**Review of the Revised Plan for
Off-Site Treatment of Newport
Chemical Agent Disposal Facility's
Caustic VX Hydrolysate at DuPont
Secure Environmental Treatment
Facility in Deepwater, New Jersey**

A Report to Congress

**Department of Health and Human Services
Centers for Disease Control and Prevention**

July 2006 - *Corrected Version*

Figure 1. Removal Efficiency of the DuPont Revised Process

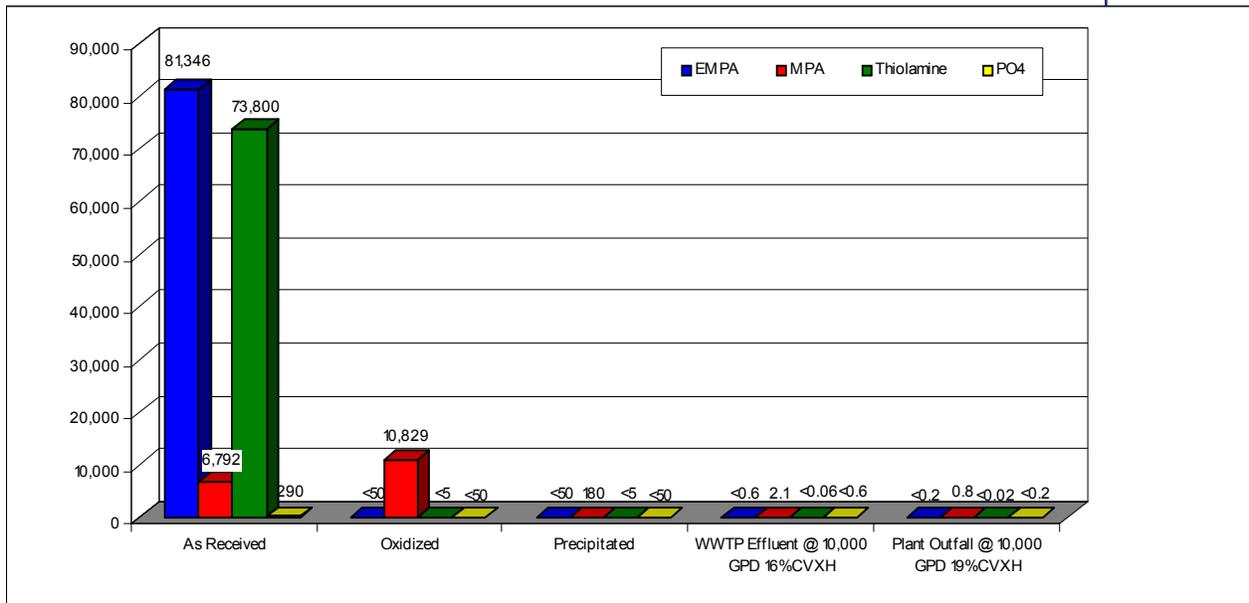
- The DuPont combined pretreatment studies demonstrate that 16% VX loaded CVXH DIC, DCC, and DIC/DCC stabilized hydrolysate can be effectively treated to remove phosphonates (EMPA and MPA) before biotreatment. The results of the testing are shown in Figure 1 (5).
